SUMMARY COMMENTS

MOSCOW - PULLMAN WATER SUPPLY
WITH SPECIAL REFERENCE TO THE
ADVISABILITY OF RELYING GROUND
WATER FROM THE PRESENTLY IDENTIFIED
GROUND WATER AQUIFERS OF THE MOSCOW BASIN

C. C. Warnick
Professor of Civil Engineering
University of Idaho

to be
presented orally to
Moscow City Council
March 1, 1971

Fig. 1 oblique view of Model Aquifer Upper Artesian Zone.

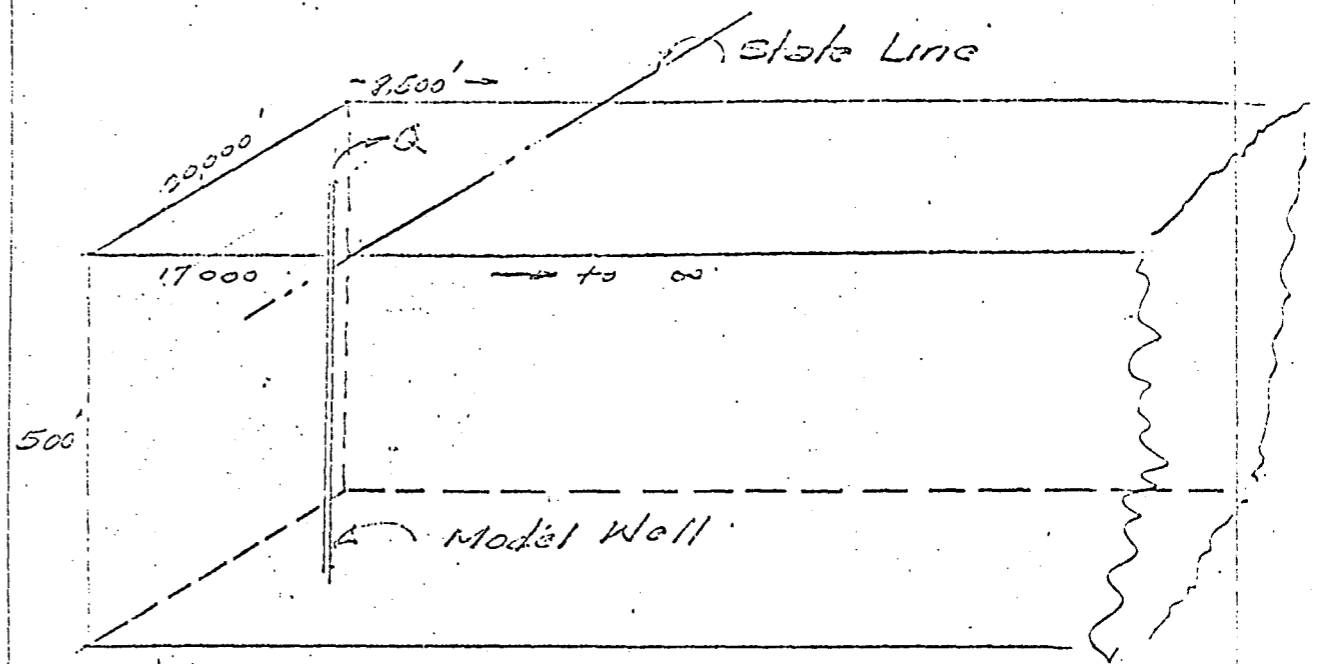
1. The aquifer is not infinite to the west as assumed and these leads to a premise that is explained orally and by the figures.
2. The model does not consider withdrawals by Pullman which appear to be drawing water from the lower aquifers.
3. The change in water levels in the aquifers could occur in the model and take an infinite time to draw down because water is coming from storage on the infinite side of the model.

A series of sketches illustrate the point here.

(Figure 1, 2, and 3.

Fig. 2 Explanation of ground water coming from storage on infinite side.

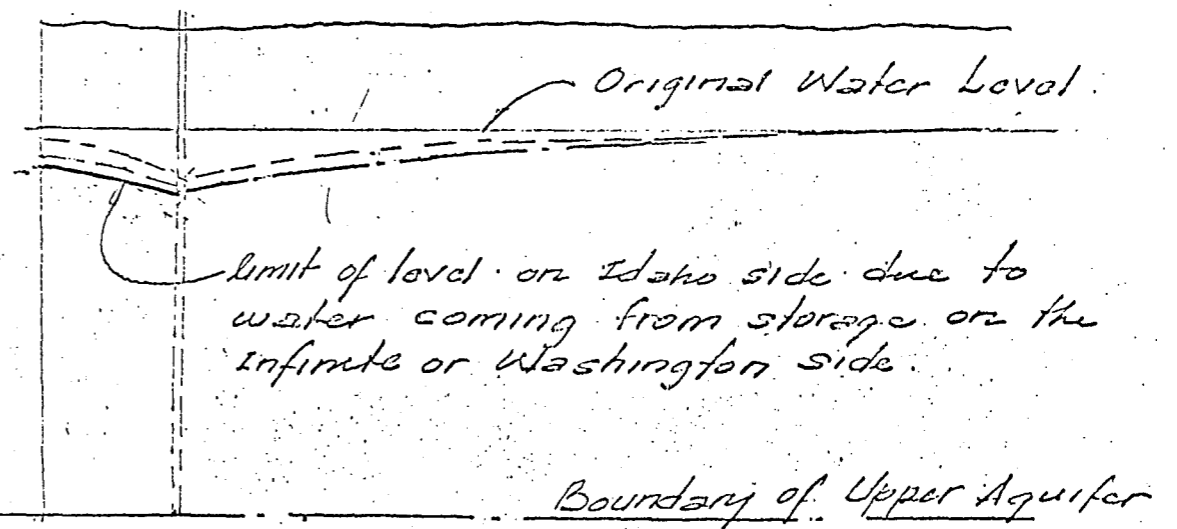
This would explain more rapid drawdown of Pullman wells in first few years.

Fig. 3 - Hypothetical sketch of Model of Bounded Infinite Aquifer with No Recharge

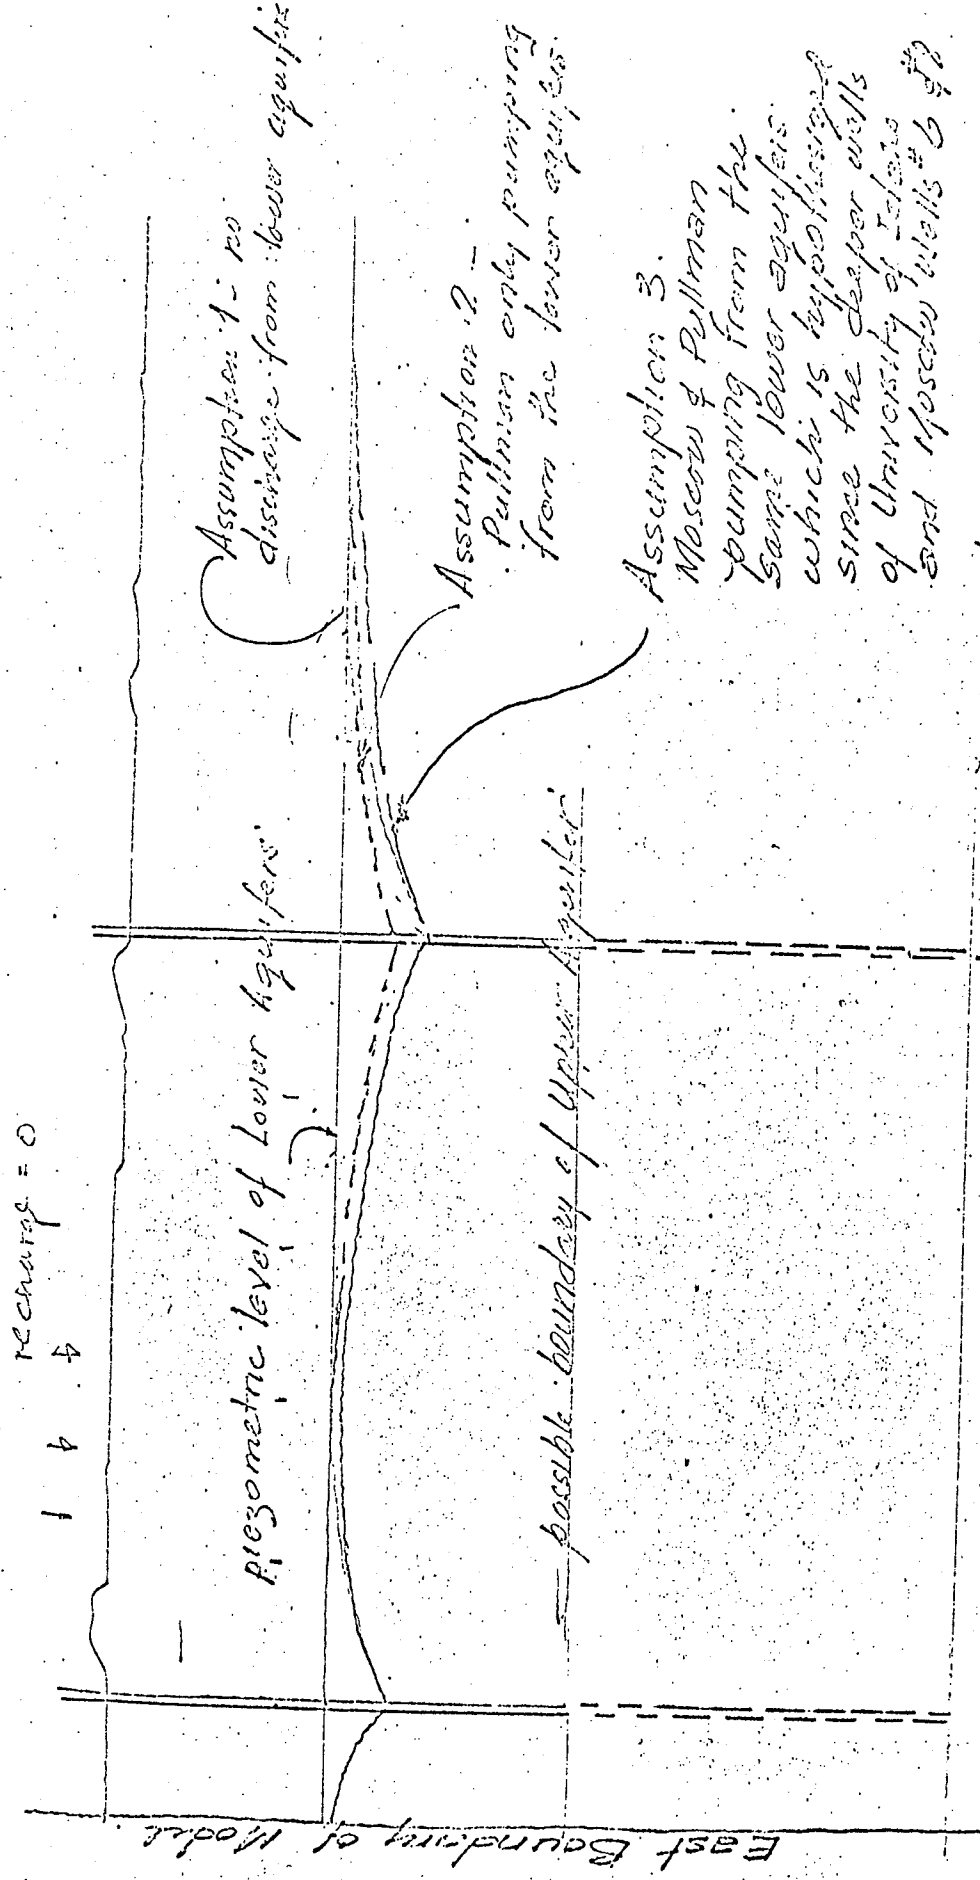
- 4. The increased rate of drop in the piegometric level in Pullman wells would give support to the questionable nature of the model. See Figure 3.
